Ripp Farms 1- lot Certified Survey Map

Town of Dane, Section 1

July 14, 2020 ZLR mtg.

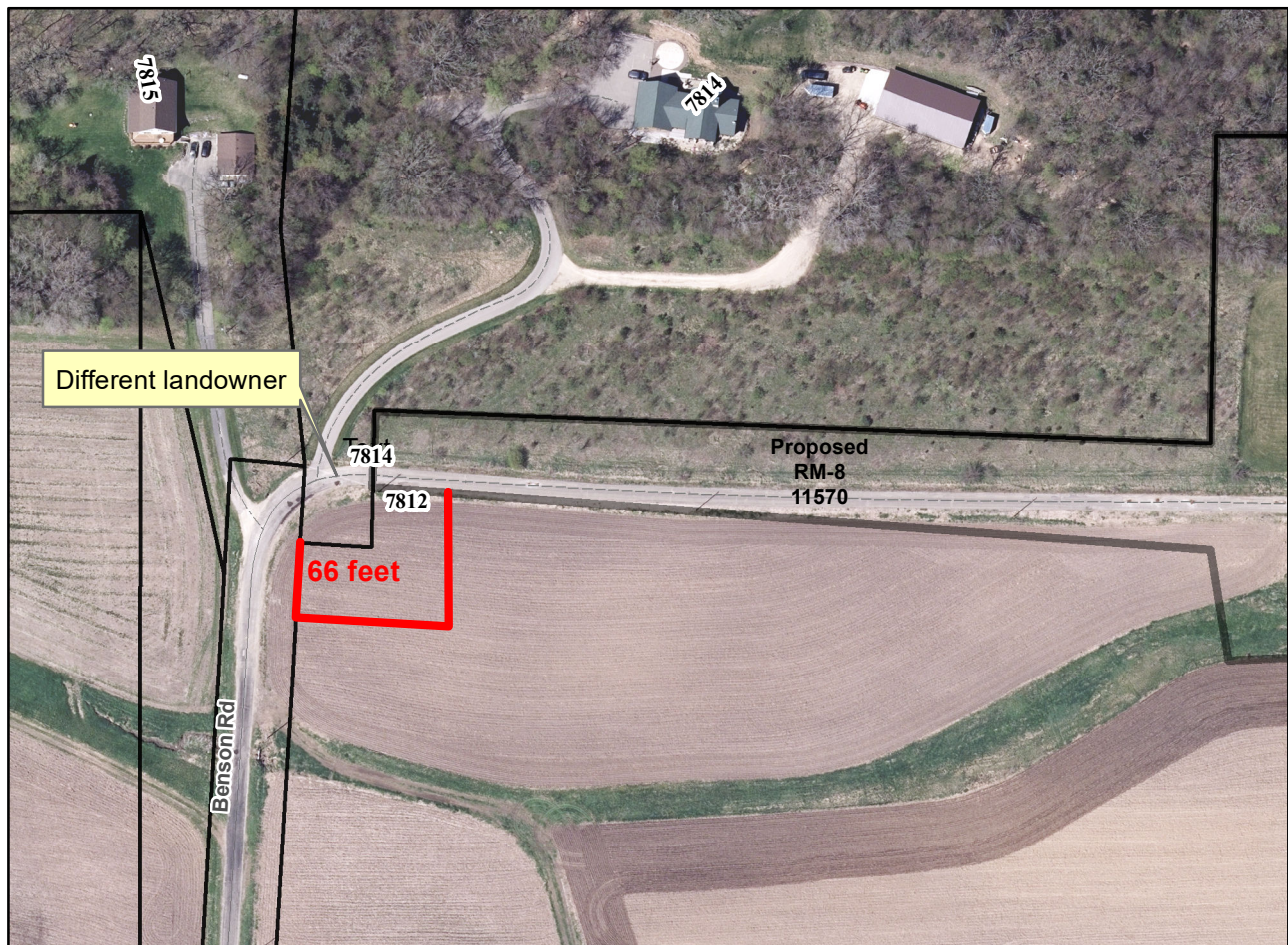
Applicant is seeking a waiver from Ch. 75.19(6)(b) to allow the proposed lot to have no frontage along Benson Rd.

Staff would suggest revising the layout of the lot to meet the design standards (66 feet public road frontage) as the landowner does have additional lands that front Benson Road that will allow for a future driveway if need be.

However, since this is existing development with an existing driveway, staff would suggest allowing for a waiver to be granted that allows the driveway to not be located within the proposed 66 feet corridor.
